### PLANNING COMMISSION MEETING AGENDA REGULAR MEETING

6. <u>PRELIMINARY SITE PLAN APPROVAL (File Number SP1019-0041)</u> – Proposed Lange View Estates, East of Crooks Road, Southeast corner of Livernois and Leetonia (4080 Livernois), Section 15, Currently Zoned NN Neighborhood Node (Node "H") District.

SUBJECT: PRELIMINARY SITE PLAN APPROVAL (File Number SP1019-0041) - Proposed

Project Name: Lange View Townhouses

C3.	O

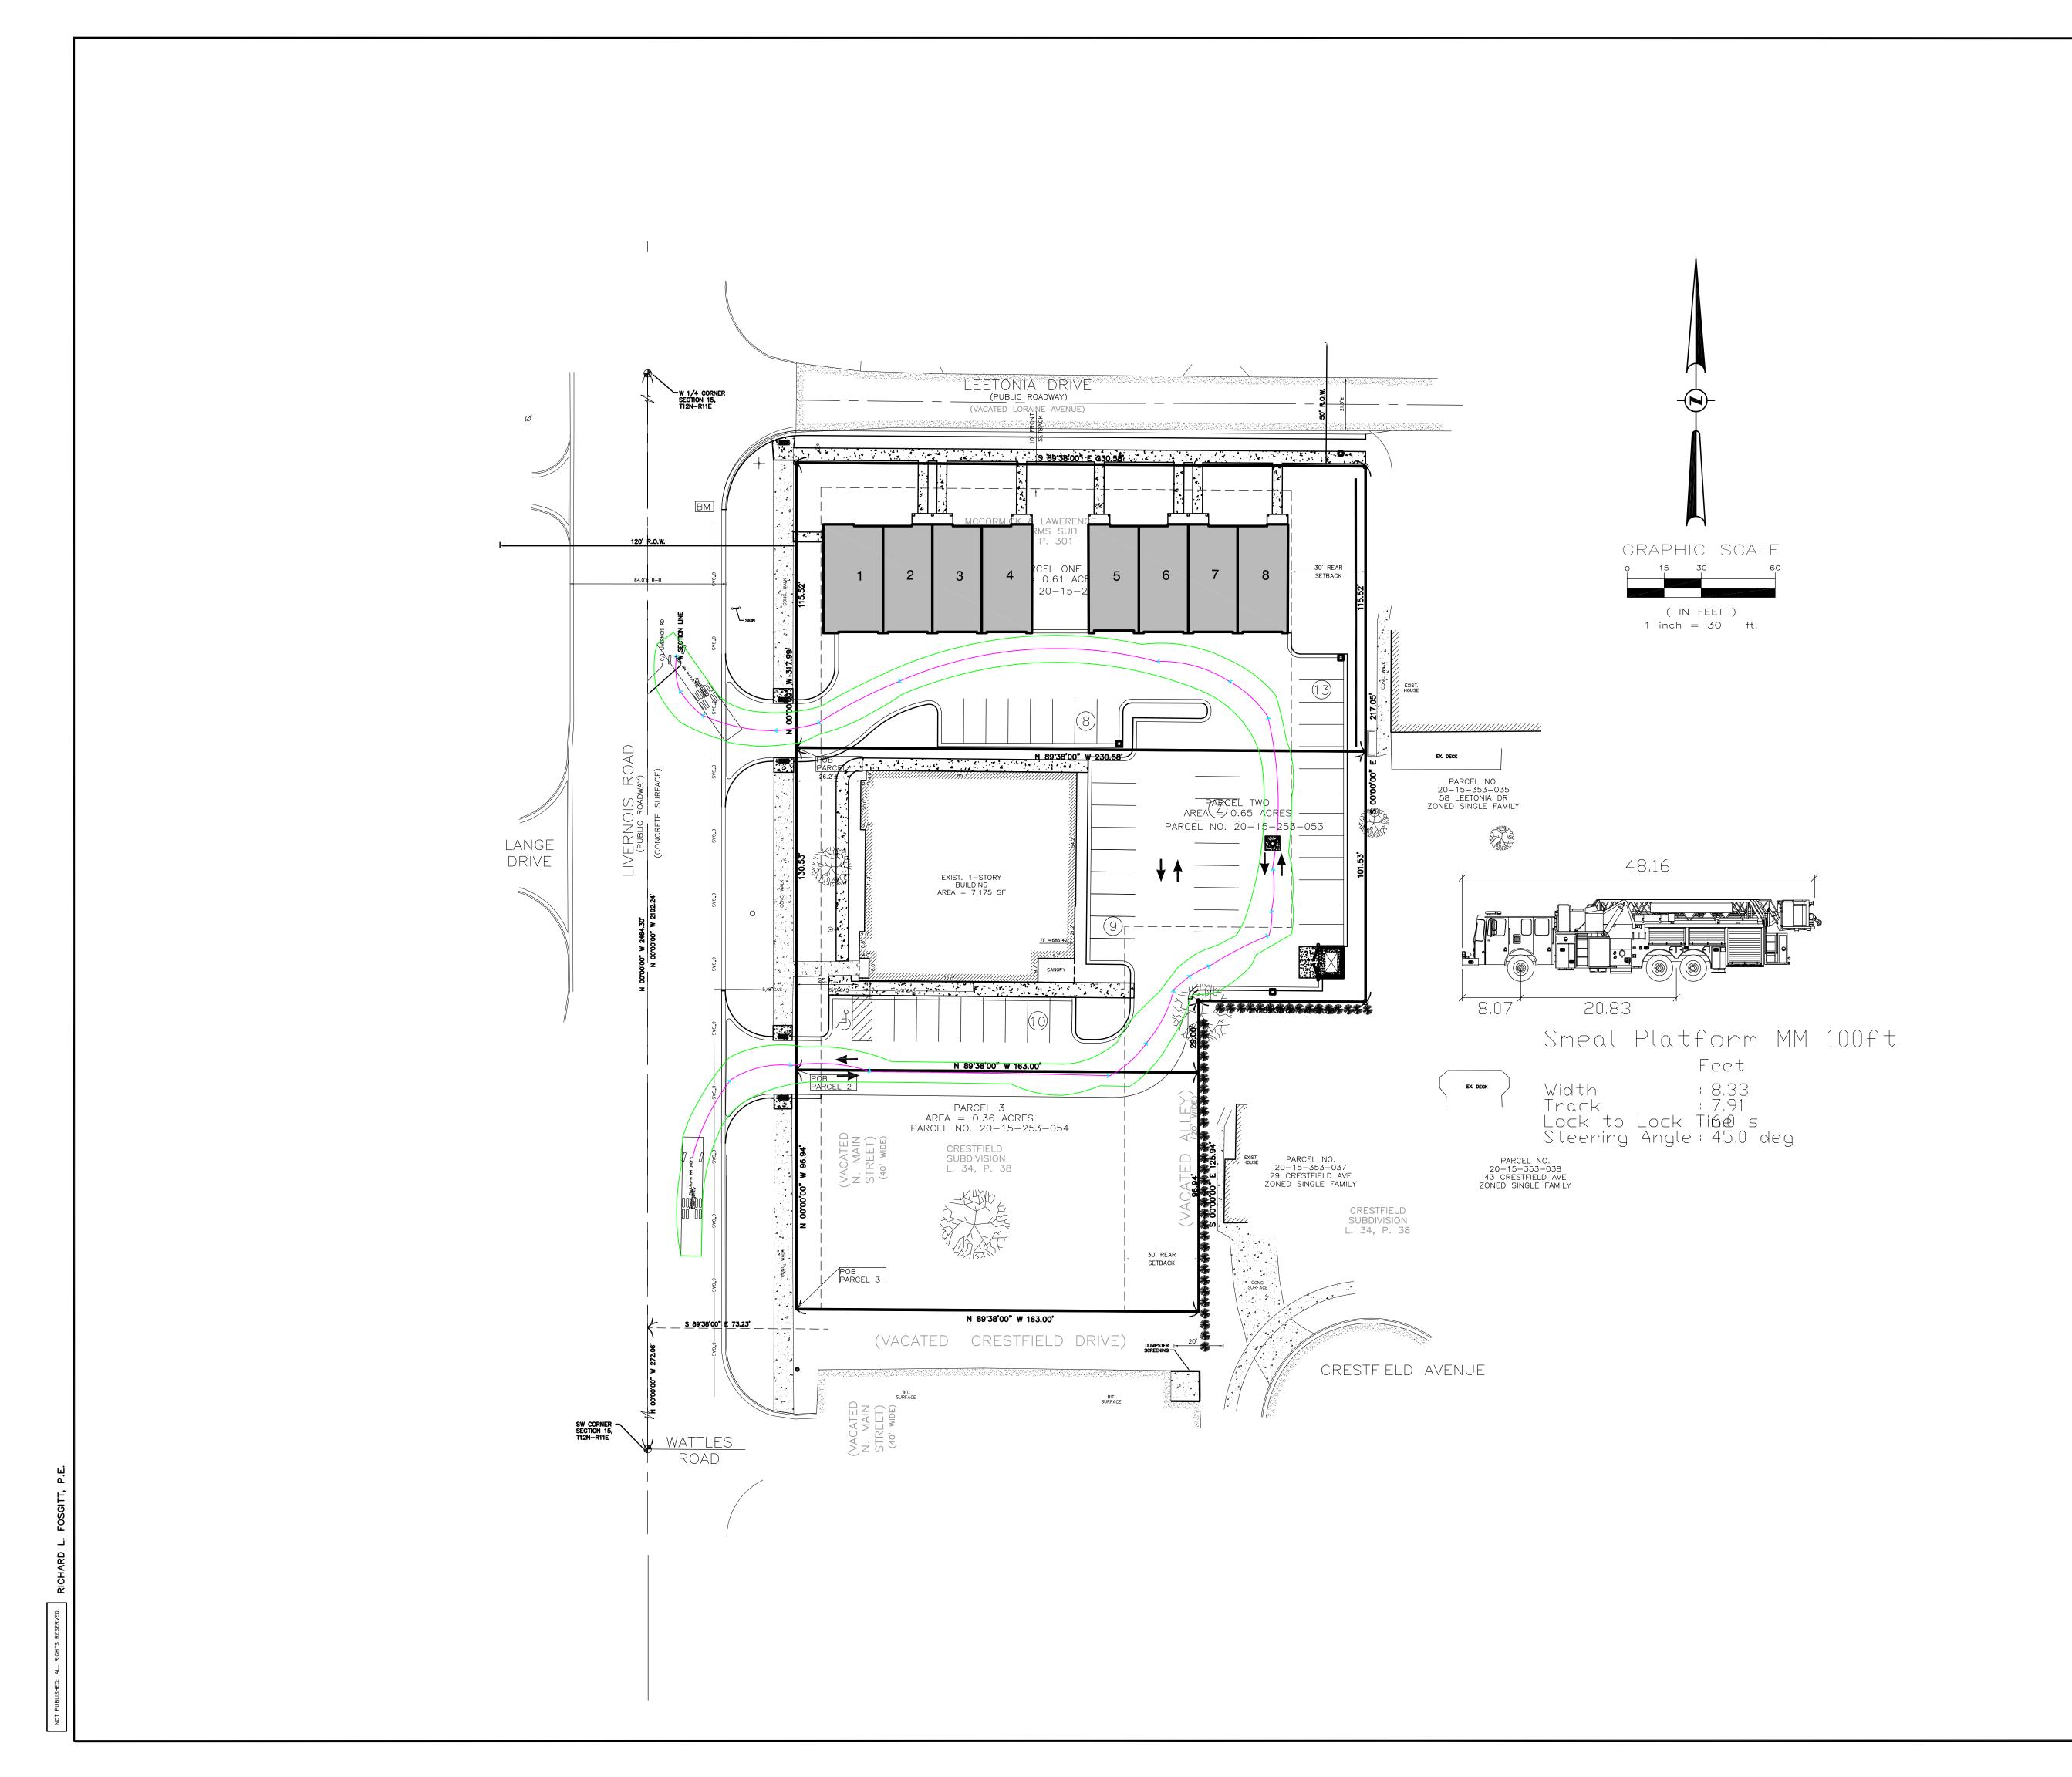
Vehicular access to the site is via Livernois Road. A turning plan has been provided on Sheet C3.1 for fire trucks and garbage trucks. Both the Fire Department and the Engineering Department note significant access and circulation deficiencies.

FD apparatus does not fit in rear parking lot. Need to reconfigure parking spaces or curbs.

- Dimensions throughout the site do not comply with City Ordinance requirements.
  - As a commercial driveway, the driveway should be 30 feet wide at the throat and with 30 feet radii. The plans currently show 22 feet wide driveways with 20 feet radii.

- o Aisles in the parking lot must be 24 feet wide.
  - o Parking spaces should be 19 feet long by 9.5 feet wide. Parking that abuts landscape areas may be reduced to 17 feet, and the landscape area shall be increased by 2 feet to accommodate vehicle bumper overhang.

- The rear parking area, located west of the office building, is awkwardly configured with poor vehicular circulation. The layout requires a vehicle to make a series of sharp turns in order to navigate from the north side of the site to the south side. The tight radii and narrow aisle width add to the difficulty. Further, the landscape screening along the southeast corner severely

restricts sight distance, so a vehicle maneuvering in this area may have limited visibility. This entire area must be reconfigured.

**Items to be Addressed:** Address the Fire and Engineering Department concerns.
